Video Products Technical Bulletin 30-2005-019R

SUBJECT: REUSE AUDIO HEAT SINK WHEN REPLACING THE A BOARD

MODEL: PVM-2950Q

*Figure 1*

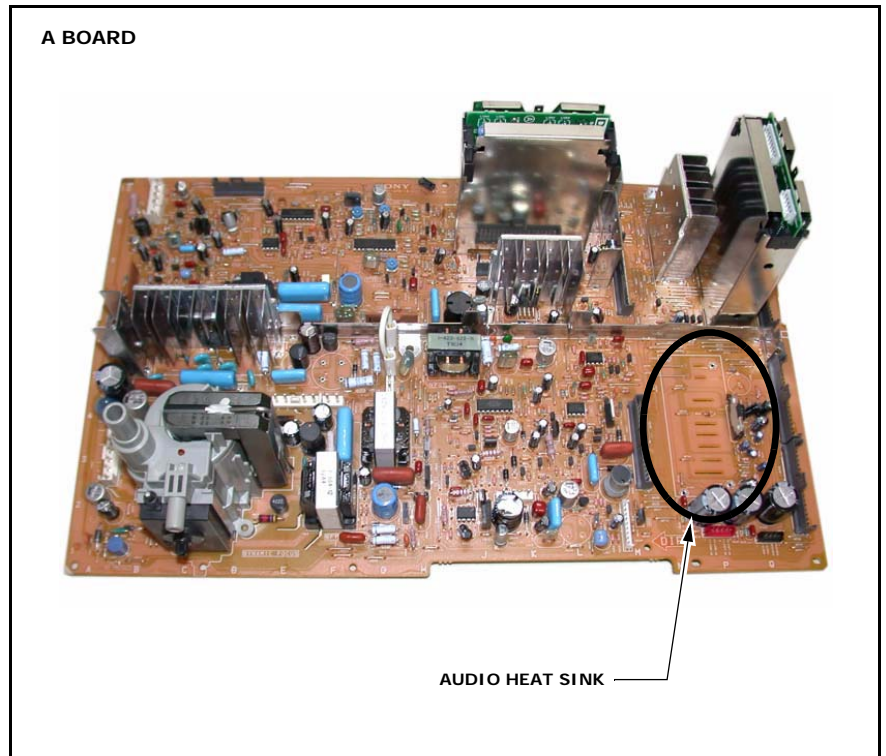
When you replace the A board (A-1297-387-B), remove the large audio heat sink (4-385-418-22) from the former board and install it on the new board.

The new A board does not contain the heat sink, and the heat sink is no longer available as a service part. (See Figure 1.)
